Report on Consultation - Route Selection

Project: LT313 Earraghail Wind Farm OHL Connection

Date: January 2023

Plate 3.1 – Preferred Route

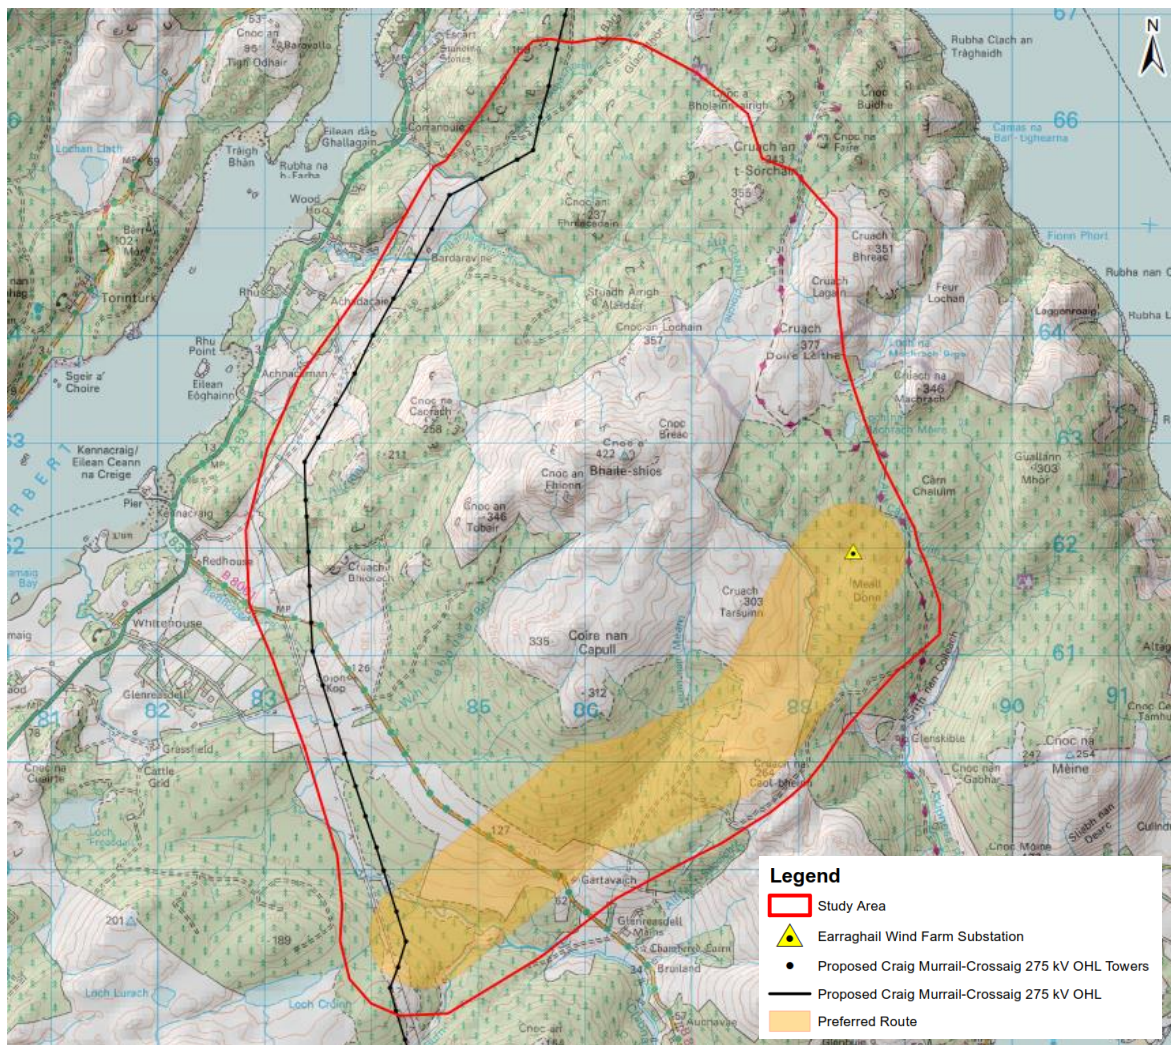
HES	<p>We note that the preferred route is currently route 1B. This route would have the potential impacts on the setting of Glenreasdail Mains, chambered cairn 200m SE of, SM3281. Route options 1A & 1B are the least-preferred options for our interests, but we are content that these could be minimised with further detailed assessment and careful design.</p> <p>The cultural significance of chambered cairns is heavily vested in the specifically local details of their settings, as such the setting of this cairn is very sensitive to change. Should Route Option 1B be progressed, we recommend that mitigation by design is undertaken to minimise impacts on the setting of the chambered cairn. This is likely to require the careful positioning of the overhead line so as to maximise the absorbing effect of the surrounding</p>	<p>SSEN Transmission acknowledge the potential for impacts on SM 3281. The asset has been considered in the route options appraisal. Further environmental studies will be undertaken at the alignment stage which will consider the potential for impacts on cultural heritage sites and assets. It is considered an acceptable alignment that minimises potential effects on cultural heritage sites and assets within the Preferred Route can be found. SSEN Transmission will continue to engage with HES</p>

RSPB	<p>SPECIES</p> <p>RSPB Scotland note that Route Option 1b is presently preferred by the Applicant. We are broadly supportive of this selection on the basis of minimising transiting of open ground habitats; however our data indicate that Route Option 1B passes closer to 2 black grouse <i>Lyrurus tetrix</i> areas of Highest Regional Priority than Route 1A.</p> <p>Black Grouse</p> <p>Argyll Native woodland comprises important black grouse habitat at a low density of ≤ 200 stems/ha. Black grouse are vulnerable to collision with unmarked barriers such as OHLs and fence lines. Data indicates that 3 areas of Highest Regional Priority and 1 area of High Regional Priority are located < 1.5 km from Route Option 1B. Route Option 1B sits well within the 5 km adult dispersal zone for 4 regionally important black grouse leks, and any degradation/loss of low-density native/Ancient Woodland could result in significant negative impacts for this special at Regional scale. Robust fieldwork will therefore be required to ascertain current levels of black grouse activity; and whether, if good numbers of birds are still present, any potential negative impacts of Route Option 1b can be mitigated.</p> <p>Raptors</p> <p>Historical data indicate that golden eagle <i>Aquila chrysaetos</i> breed to the north-west of the proposed Crossaig substation within the Study Area. Route Option 1B passes furthest from this site. White-tailed eagle activity has also been recorded through the Study Area.</p> <p>The cumulative impact of renewable energy developments/peripheral infrastructure on Kintyre's territorial pairs must be given fulsome consideration to safeguard these iconic birds, which are protected under Schedule 1, Schedule A1 and Schedule 1A of the Wildlife and Countryside Act 1981.</p>	<p>SSEN Transmission note RSPB's comments on the Preferred Route. The potential for impacts upon Black Grouse and Raptors were considered within the Consultation Document and will continue to be considered through future design stages and assessment work as we seek to find an acceptable alignment that minimises potential effects on these sensitive species.</p> <p>Consultation with Argyll Raptor study group will be undertaken at the alignment stage with regards to the scope of ornithological surveys and any relevant data they may hold.</p> <p>Opportunities for habitat enhancement, i.e. blanket bog restoration and connectivity will be considered in line with SSEN's Routeing Guidance.</p> <p>SSEN Transmission recognise the importance of establishing a holistic approach to assessment. The potential cumulative impact is considered in the development and appraisal during routeing as well as part of the EIA.</p> <p>Cumulative impacts will be taken into consideration with other environmental, engineering and economic factors to select a proposed alignment which is economically viable, technically feasible, minimises impacts on important resources or features of the environment and reduces disturbance to those living in it, working in it, visiting it or using it for recreational purposes.</p>
